Attachment-13 Departmental and Agency Comments

Date	September 26, 2024
To	Lindsay Sulatycki, Senior Development Planner
From	Ryan Mallory, Park Planner
Service Area	Public Services
Department	Park and Trail Development
Subject	601 Scottsdale Drive - Proposed Zoning By-law and Official Plan Amendment – OZS24-007

Re: OP & ZBA Pre-Submission – MTO Comments (601 Scottsdale Dr. Guelph ON)

Date October 28, 2024
To **Lindsay Sulatycki, Senior Development Planner**
From Louis de Jong, C.Tech
Engineering Technologist III
Service Area Infrastructure, Development and Enterprise Services
Department Engineering and Transportation Services
Subject 601 Scottsdale Drive
Formal Submission

Figure 6: Highway 6 and Stone Road - Setback for 601 Scottsdale Drive - MTO

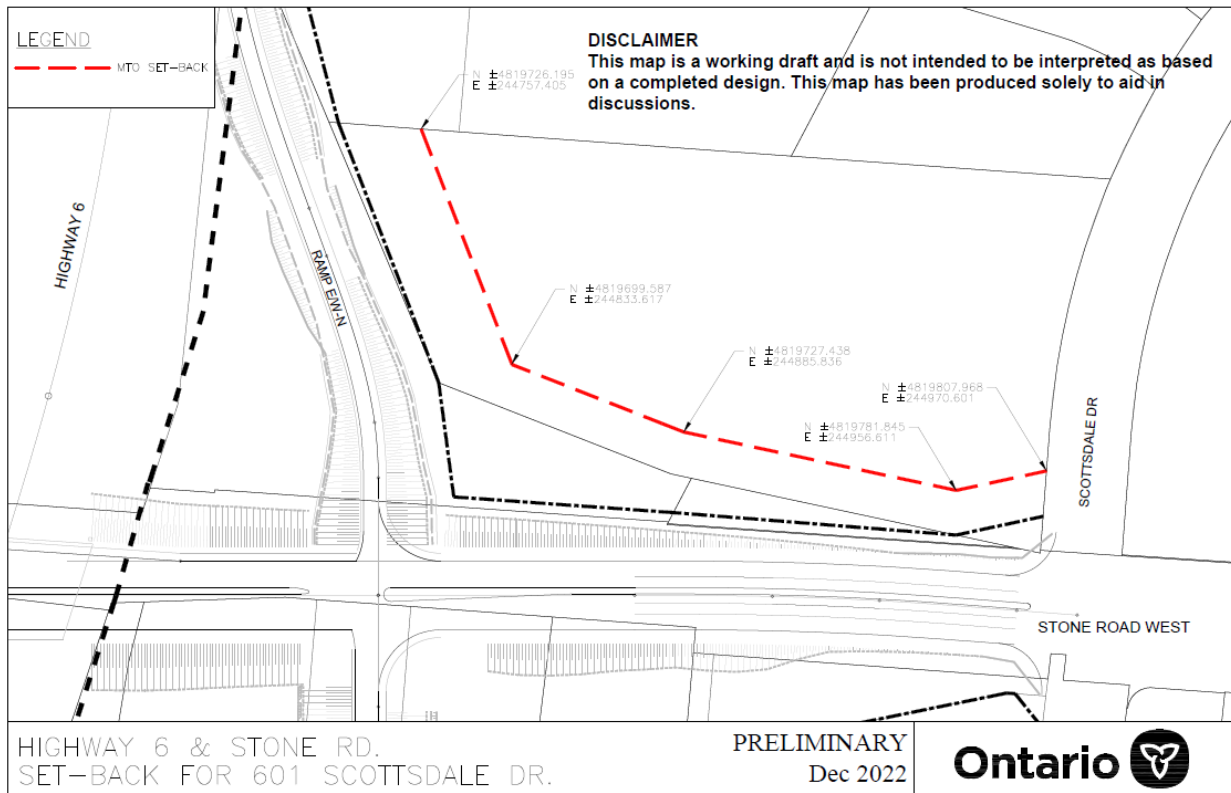
As previously communicated, the Highway 6 and Stone Rd intersection is proposed to have major reconstruction work occur, under a future highway improvement project that converts Highway 6 from a staged freeway to a fully interchanged controlled freeway. To facilitate these required improvements additional lands will be required to be protected. As such MTO had provided an enhanced setback line which was to be achieved and shown on future site plan submissions ("Stone Road Set-Back Map - Dec 2022 – Disclaimer.pdf"). The latest submission does not meet the required setback, with integral components to the development being located within the setback line, see "MTO Setback Mark-up.pdf" for reference.

- All buildings, structures and features integral to the site to be located beyond this setback line from the highway property limit, inclusive of parking, drive aisles, above and below grade infrastructure, etc. The MTO setback is to be applied and shown on the future site plans from
 - There are a number of integral elements proposed within the MTO setback line, including:
 - Portions of the 6.5m wide drive aisle/fire route, including the turn-around and access to the internal loading areas;

- Pedestrian walkway and other amenity spaces; and
- Approx. 32 parking spaces along the easterly property line of the subject site.
- Alternative site configuration should be investigated to meet the required MTO setback limit.

- Revised Site Plans, Site Grading Plans, Site Servicing Plans, Landscaping Plans, Illumination Plans, Sediment and Erosion Control Plans that achieve the identified MTO setback limit shall be submitted to MTO for review and approval.
